A318/A319/A320/A321

SERVICE BULLETIN REVISION TRANSMITTAL SHEET

TITLE : AIR CONDITIONING - COCKPIT AIR HEATING - IMPROVE FOOT WARMER EFFICIENCY.

This page transmits Revision No. 01 of Service Bulletin No. A320-21-1908.

Figure 1 Sheet 1
Config. 01 thru 03 : Removal of the Duct for Access.

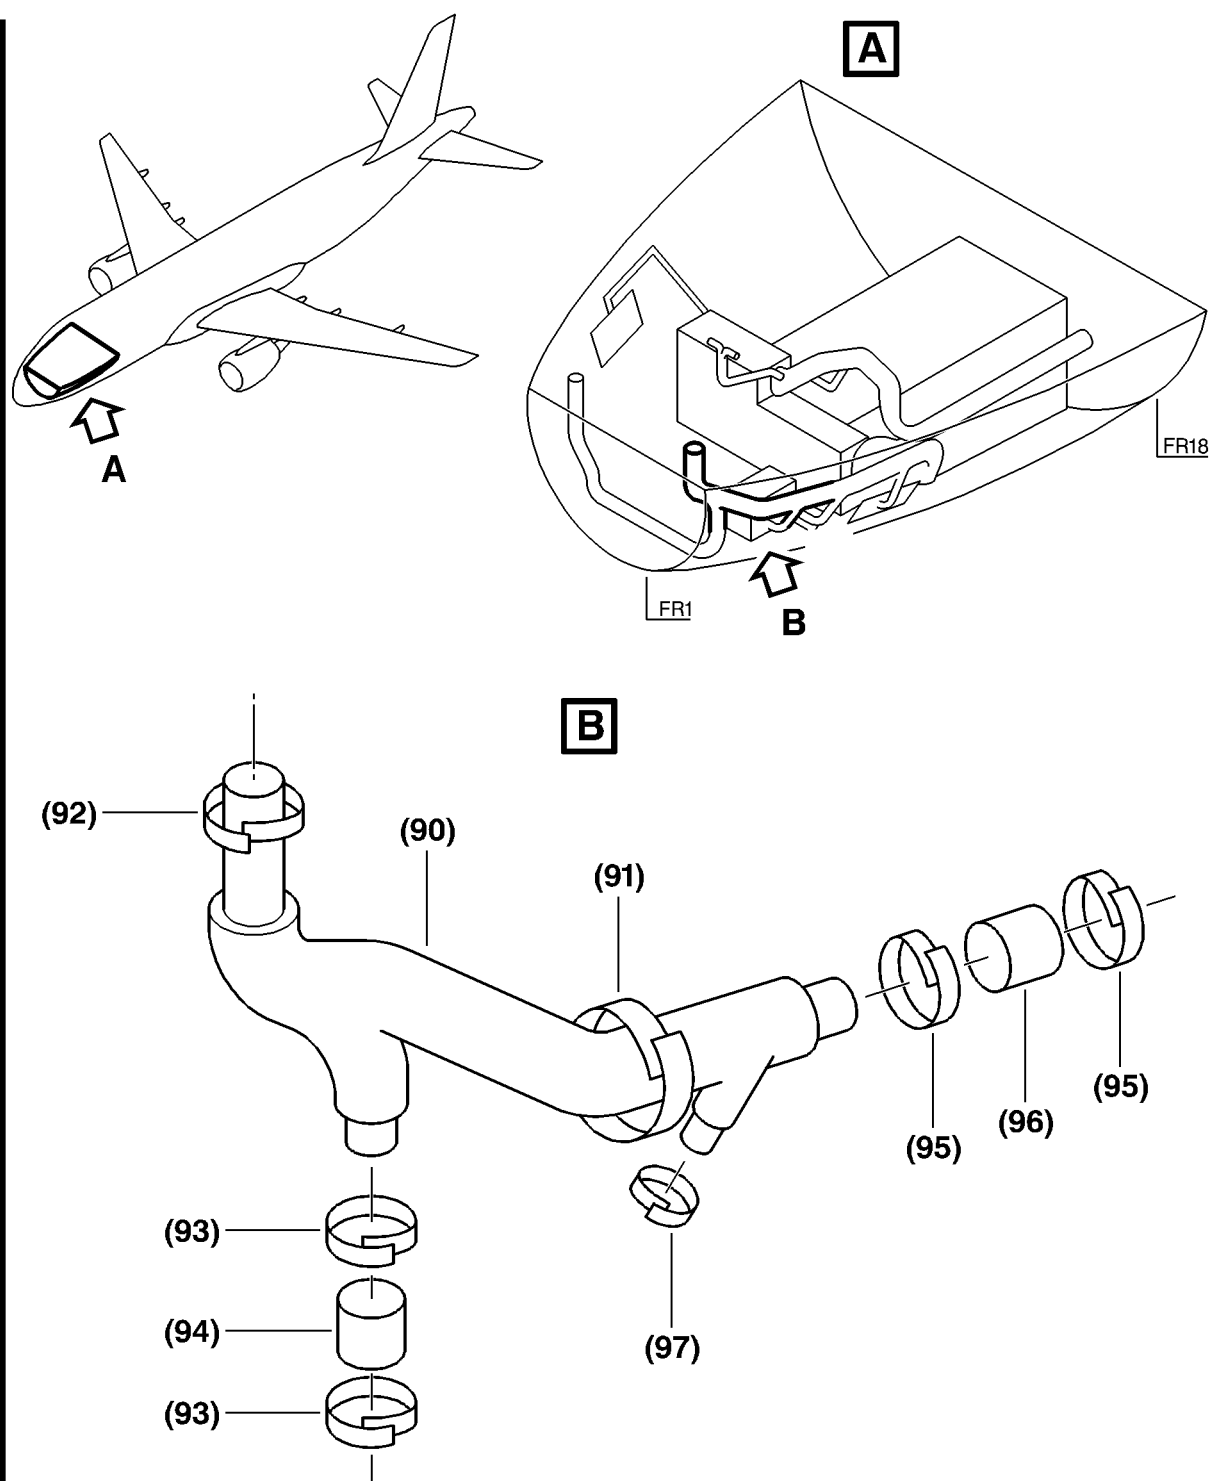
- Figure 1 added.
- Figure 4 added.
- Figure 6 sheet 3 updated and sheet 4 added.
- Figure 8, sheet 1 modified.
- Figure 9, sheet 1 modified.
- Figure 11, sheet 1 modified.
- Figure 14, sheet 1 and sheet 2 added.
- Figure 18, sheet 1 modified.
- Figure 21, sheet 1 modified.
- Figure 23, sheet 1 modified.
- Figure 24, sheet 1 modified.
- Figure 25, sheet 1 modified.
- Figure 26, sheet 1 modified.
